KANSAS GAS AND ELECTRIC COMPANY

KMLNPC 81-110
Re: Docket Number STN 50-482
Ref: NRC Letter dated 8/7/81 from RL Tedesco, NRC,
to GLKoester, KG&E

The referenced letter requested additional information in the area of geotechnical engineering. Transmitted herewith are responses to questions in the referenced letter. The outstanding response to question 241.5 WC, Items 2 thru 5, will be forwarded to you on October 1, 1981. This information will be formally incorporated into the Wolf Creek Generating Station, Unit No. 1 Final Safety Analysis Report in Revision 6. This information is hereby incorporated into the Wolf Creek Generating Station, Unit No. 1 Operating License Application.

FIGURE 241.13-3
CONSOLIDATED-UNDRAINED
TRIAxIAL TEST RESULTS
ULTIMATE HEAT SINK DAM

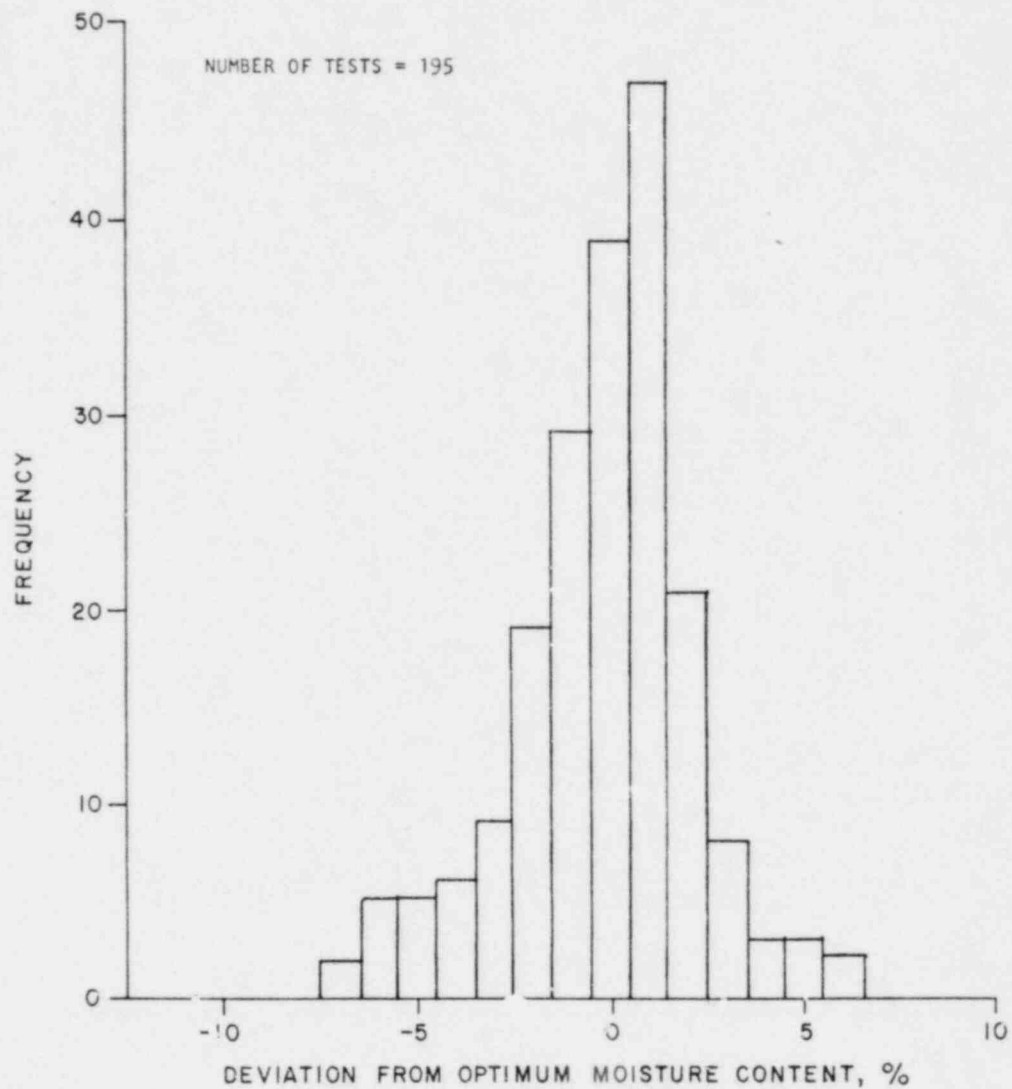
Q241.13 Provide a summary of the results of field density and moisture content tests performed in connection with quality control during construction of the UHS dam. Present the results as a statistical distribution plot or by other convenient method(s) to verify that the specified compaction has been attained. Compare the compacted in-situ density and moisture content of the embankment fill with those of the test specimens from which the design strength parameters have been determined by laboratory testing. Based on the above comparison, comment on the validity of the physical and strength parameters used in the design.

Triaxial tests on six samples obtained from three different boreholes drilled in the UHS-embankment were also performed. The test results are shown on Figure 241.13-3 and Table 241.13-1. As can be seen, all tests yielded strengths higher than the design strength. Based on this information, the strength parameters used in the design are valid.
